Subject: **PALEN SOLAR HOLDINGS, LLC'S RESPONSE TO WORKSHOP QUERIES**
PALEN SOLAR ELECTRIC GENERATING SYSTEM
DOCKET NO. (09-AFC-7C)

Response to Workshop Queries

PALEN SOLAR ELECTRIC GENERATING SYSTEM

(09-AFC-7C)

FIGURE DR 5-3 TO PSH'S DATA RESPONSES SET 1

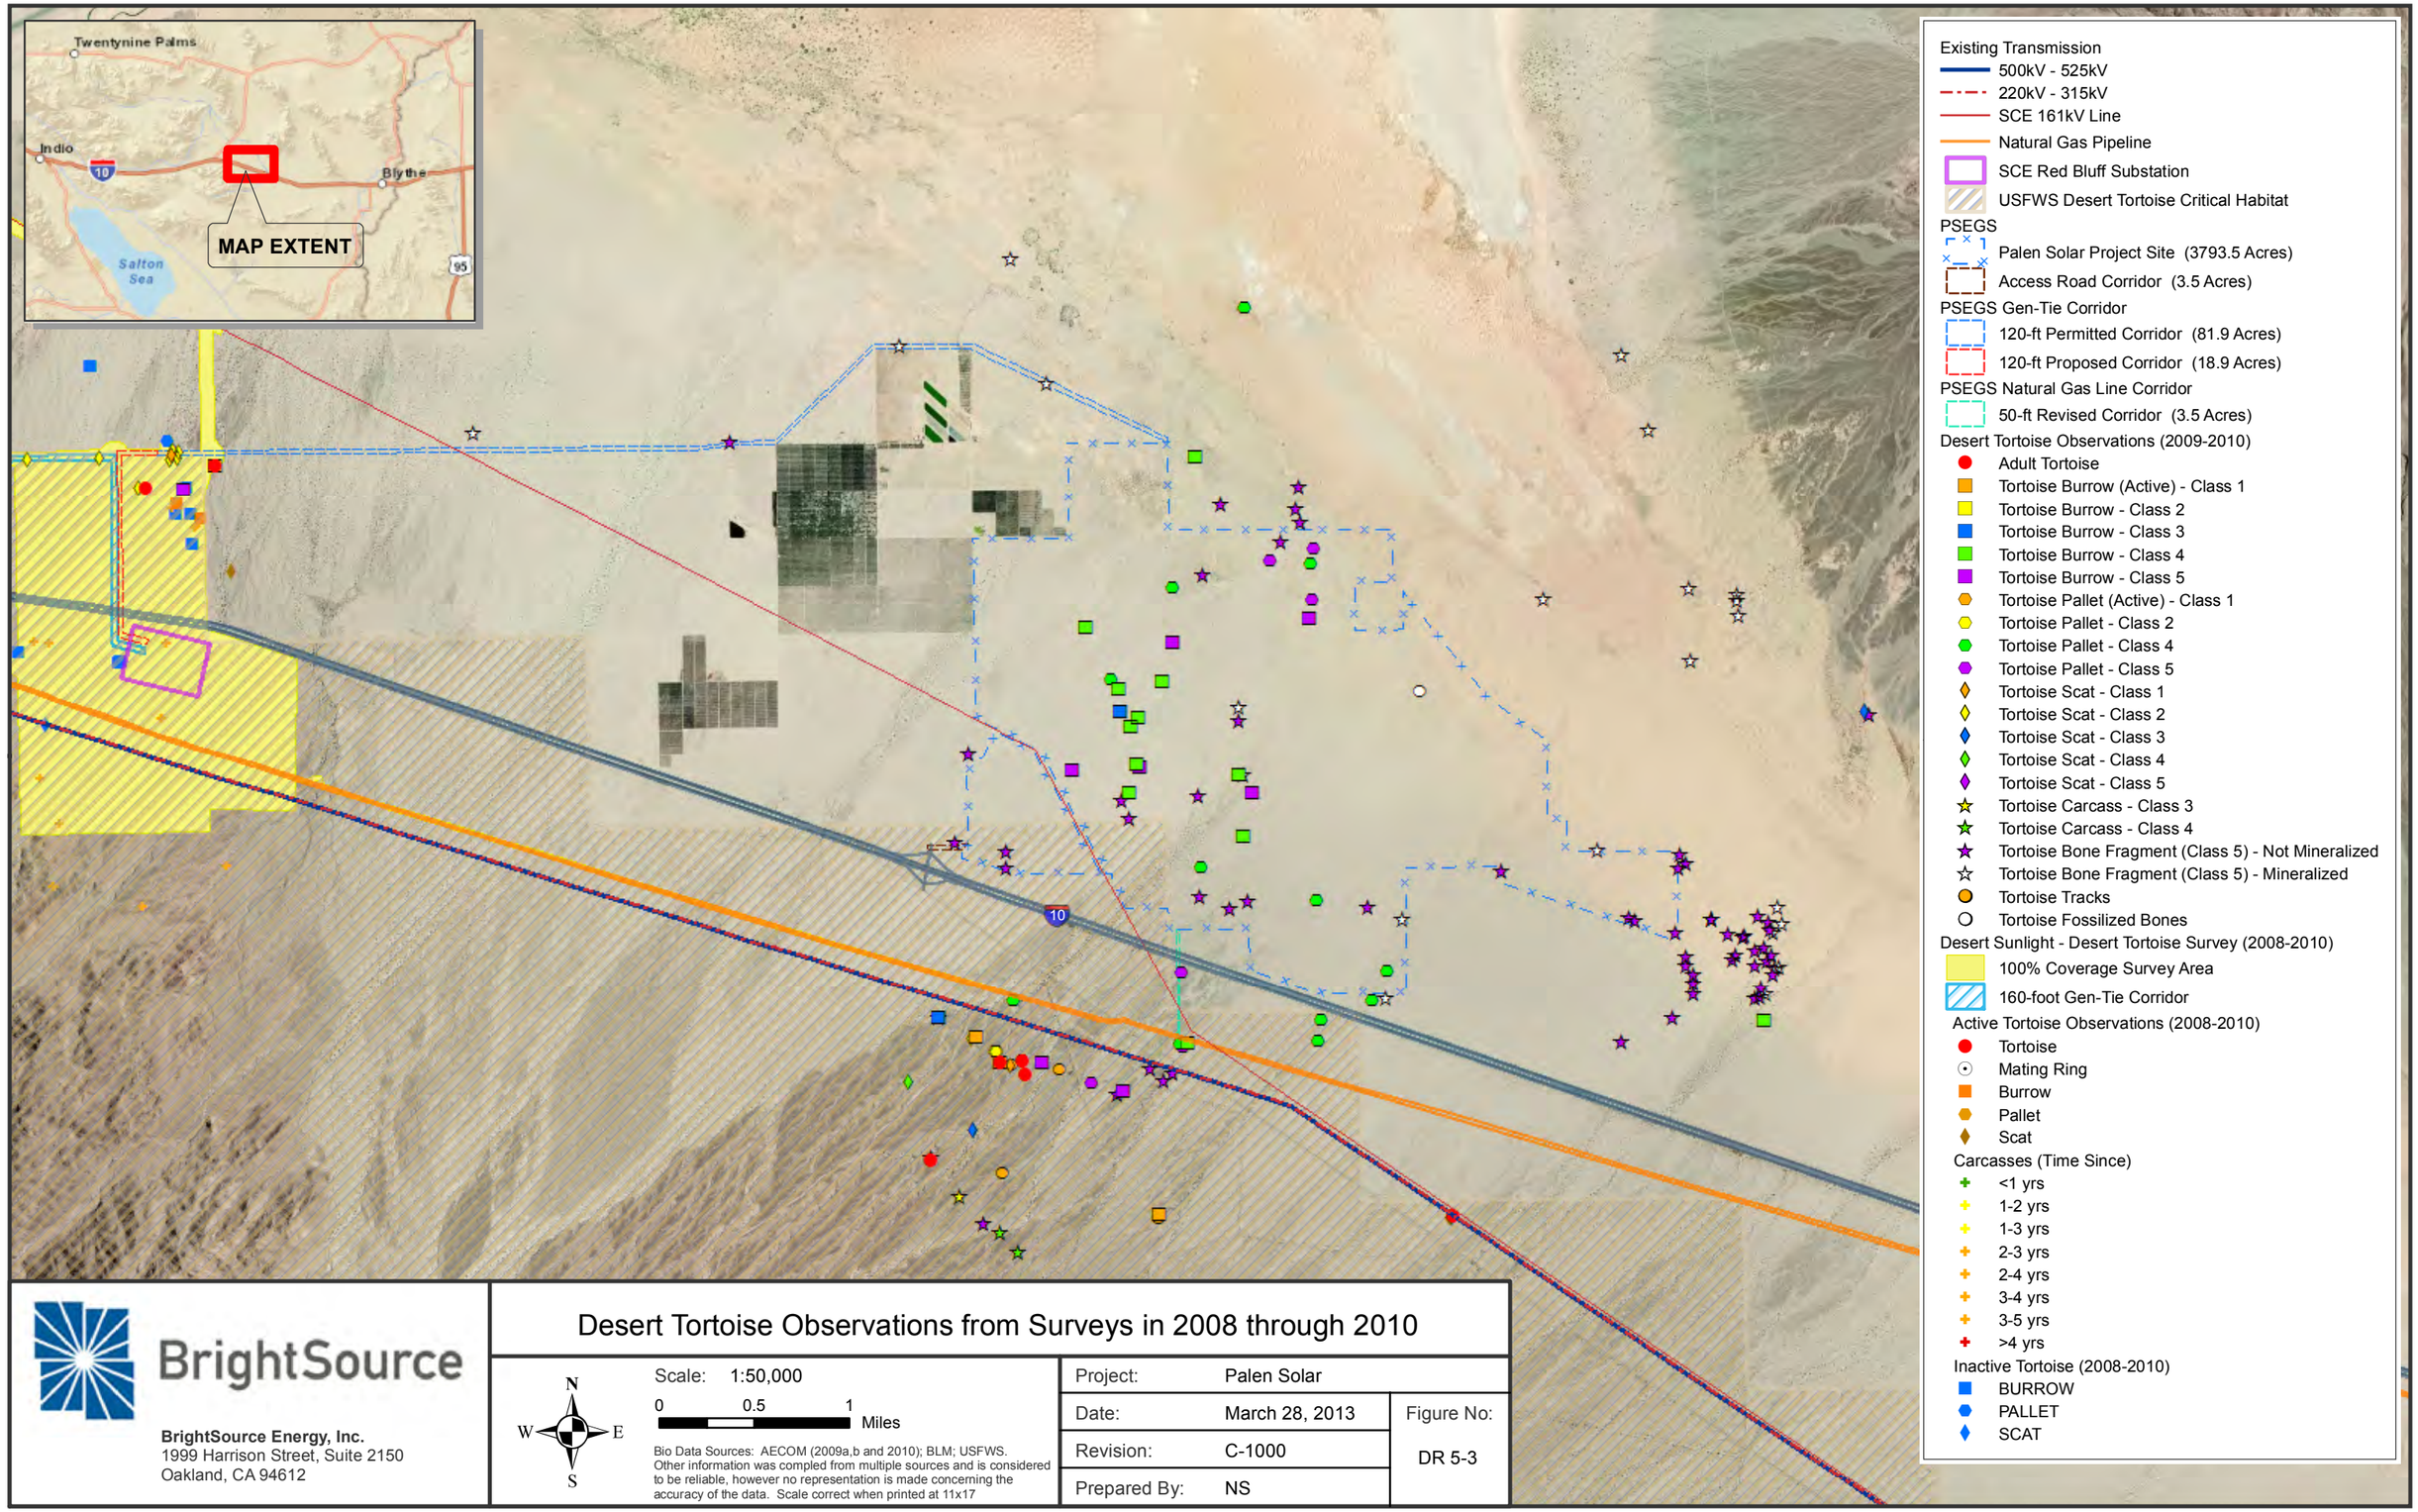
WSQ 1-6 How close is the PSEGS gen-tie line to the Desert Sunlight survey area?

The westerly shift of the PSEGS generation tie line was elected for the purpose of locating the line adjacent to the permitted Desert Sunlight generation tie line. The westerly shift is entirely within the Desert Sunlight Survey Area as shown in Figure DR 5-3 to PSH's Data Responses Set 1. See Attachment WSQ 1-6-1.
